Project: GREATER KARACHI BULK WATER SUPPLY SCHEME, K-IV

Consulting Contract: DETAILED DESIGN AND CONSTRUCTION SUPERVISION OF GREATER KARACHI BULK WATER SUPPLY SCHEME K-IV, PHASE I, 260 MGD

Client: KARACHI WATER & SEWERAGE BOARD (KW & SB)

14	Scoring Criterion

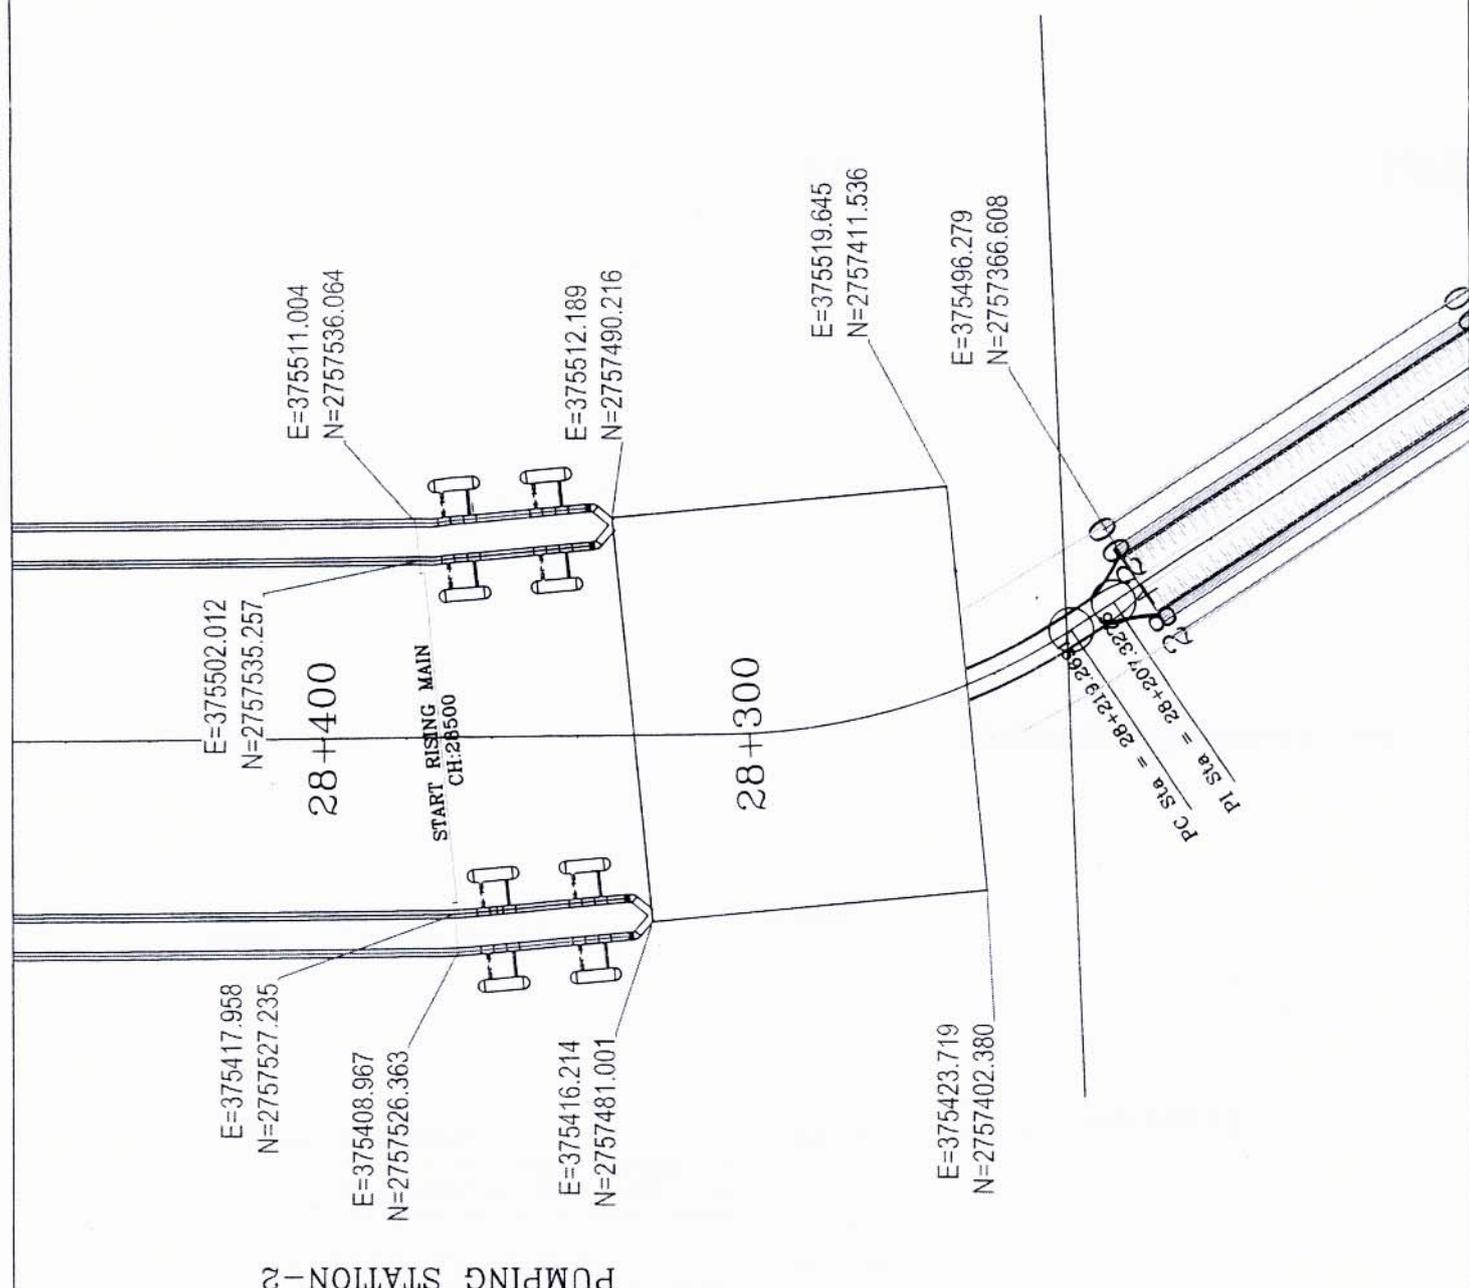
S. No.	Clarifications Sought	Client Response
	<p>The scoring criteria of having experience of 7 "thermal" power projects may please be amended and updated to just power projects as there is scope of renewable/hybrid power generation. Whilst it has been discussed that inclusion of thermal projects is a must, we suggest some points to be allocated for non-thermal projects as well (e.g either 7 thermal projects / 4 thermal + 3 renewable) in order to cater for a hybrid solution which has the potential of lowering overall levelled tariff / cost per kWh</p>	<p>Feedback has been constructively taken. Please find the changes in the addendum to the RFP.</p>
<p>15</p>	<p>Milestone payments and other payment related issues We strongly request the payment schedule to be revised as per the table below. (Attached Annexure I). We would also encourage 'inception report' to be added to the milestones so that the Client and Consultant are on the same page before delving into detailed technical studies. Furthermore, more weightage (in terms of payment) should be given to technical studies as it warrants a lot of effort / utilization of resources Please do consider making direct payments to each consortium member at this stage and amend agreement accordingly. Current feasibilities with the Energy Department, Government of Sindh can be used as a precedent.</p>	<p>Feedback has been constructively taken. Please find the changes in the addendum to the RFP.</p> <p>We believe the draft Consultancy Contract is currently structured accordingly to allow for direct payments to each Consortium member. Any other changes to incorporate the understanding have been made in the addendum to the RFP.</p>

State of Drawing: Forebay - II Coordinates

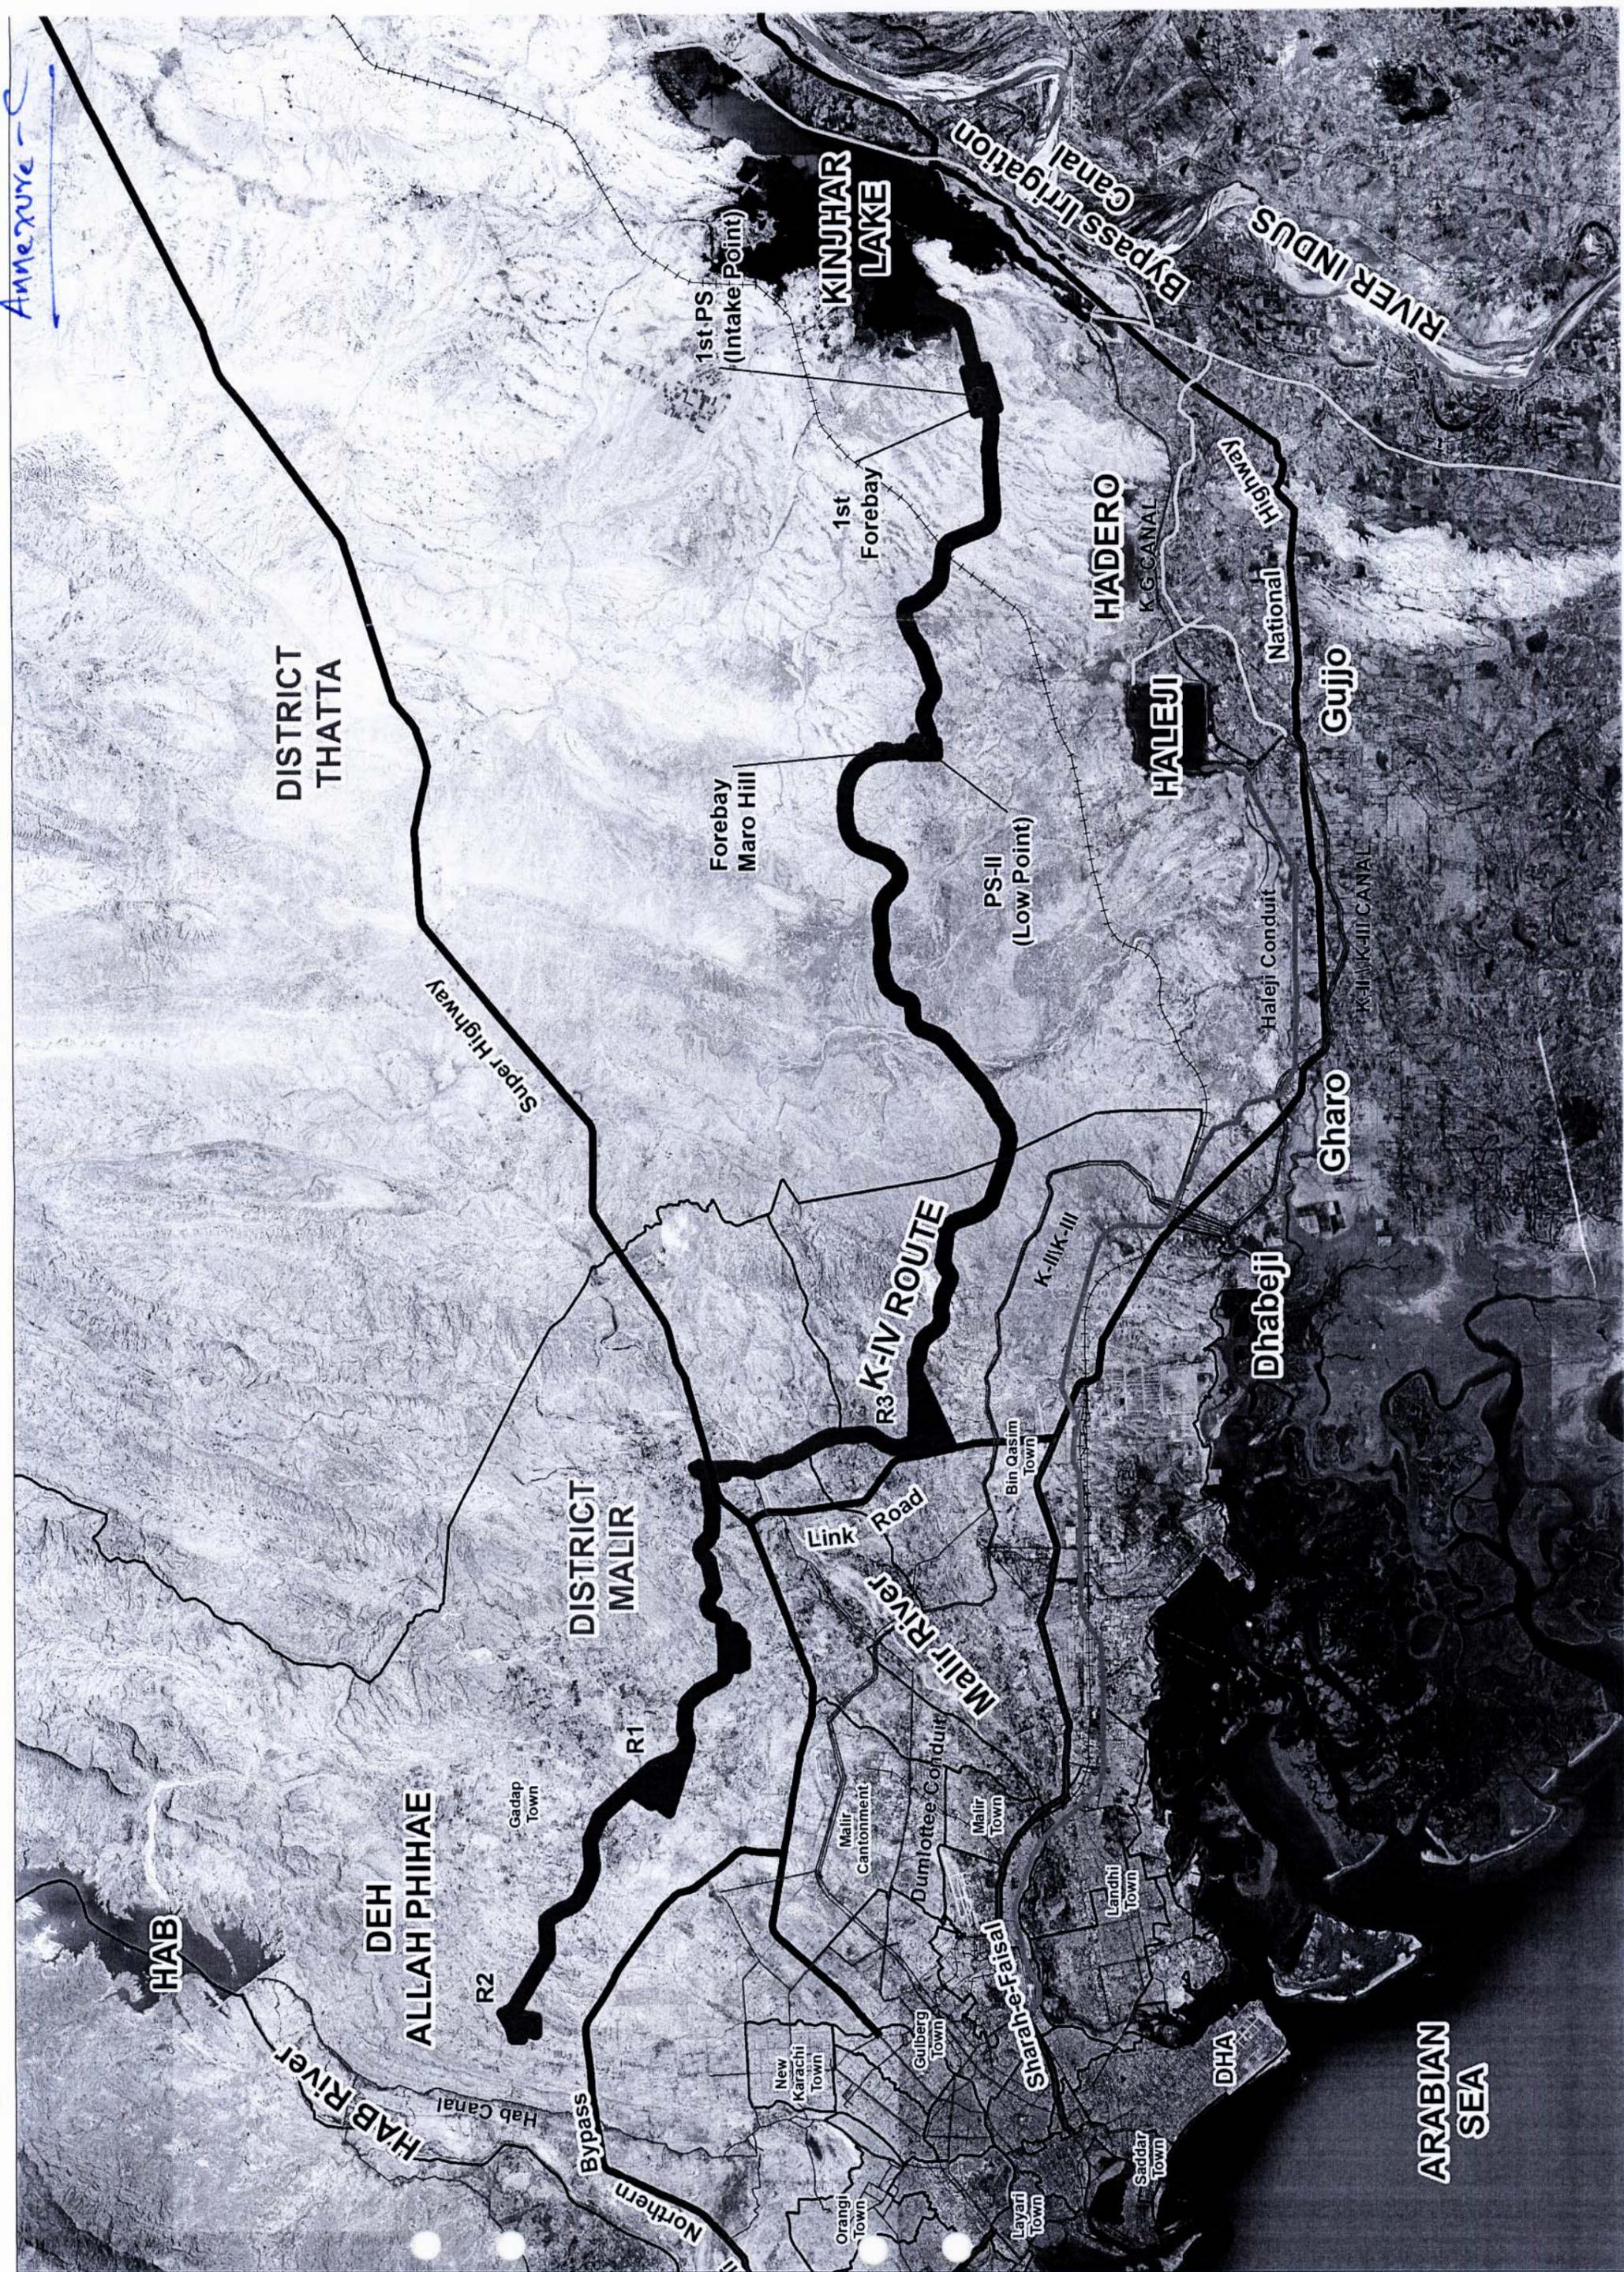
S. No.	Clarifications Sought	Client Response
1	Please provide the coordinates of the existing pumping facilities along with the expected areas under the project boundary. This information is important to estimate the efforts for desktop and on ground surveys required for the feasibility study.	Attached Sheet shows Coordinates of PS-I & PS-II and existing Utility area (Anexx A, B & C). Land for Power plant should be selected and acquired Separately
2	Geotechnical services are not mentioned in the scope which might be required for the preliminary civil design. Is Geotechnical report already available with client and the same shall be shared with the consultant. Please confirm.	While the KWSB team may share geotechnical studies of nearby geographical region, any technical study including Geotech/topographic etc will need to be conducted by the Consultant and is included in the scope.
3	The scope of work does not define any preference of a specific technology and fuel alternative for the thermal power generation. As a consequence, various consultants may comprehend the scope differently and eventually will offer according to their interpretations which might be different than the others. For competitive bidding, it is suggested to fix at least the number of technology options and number of fuel alternatives (NG, LNG, Coal, Furnace Oil) for the feasibility study. Moreover, different fuels have different logistic requirements and it is imperative to fix the alternatives for precise quantification of scope of works under logistics review. Please confirm the preferred technologies and number of technology options and fuel alternatives.	KWSB is open to a hybrid option as long as uninterrupted power supply at affordable rates is available. We are aware that the power mix will definitely include thermal solution.

S. No.	Additional Clarifications dated 2018-June 5	Client Response
19	We understand there shall be two pumping stations under Phase-1, having 20 MW & 30 MW load and located 28 KMs apart. Land coordinates for each pumping station site if available may please be provided.	Please find response under point 1 above.
20	Has any understanding with SSGC or other Gas supplier for the supply of gas for 50 MW project been developed and what is its current status?	Our preliminary findings suggest that there is a nearby gas infrastructure/pipeline in place near the pumping stations. Further information can be attained through site visit(s)
Additional Comments/Clarifications raised during Pre-bid Meeting		
21	It is recommended that Performance Security amount be reduced from 3% of the Bid Price to 1% of the Bid Price.	Performance Security amount has been reduced to 1% of the Bid Price
22	It is kindly requested to extend the proposal submission date for 02 weeks to enable our consortium/JV to prepare and submit a comprehensive and competitive proposal	No change
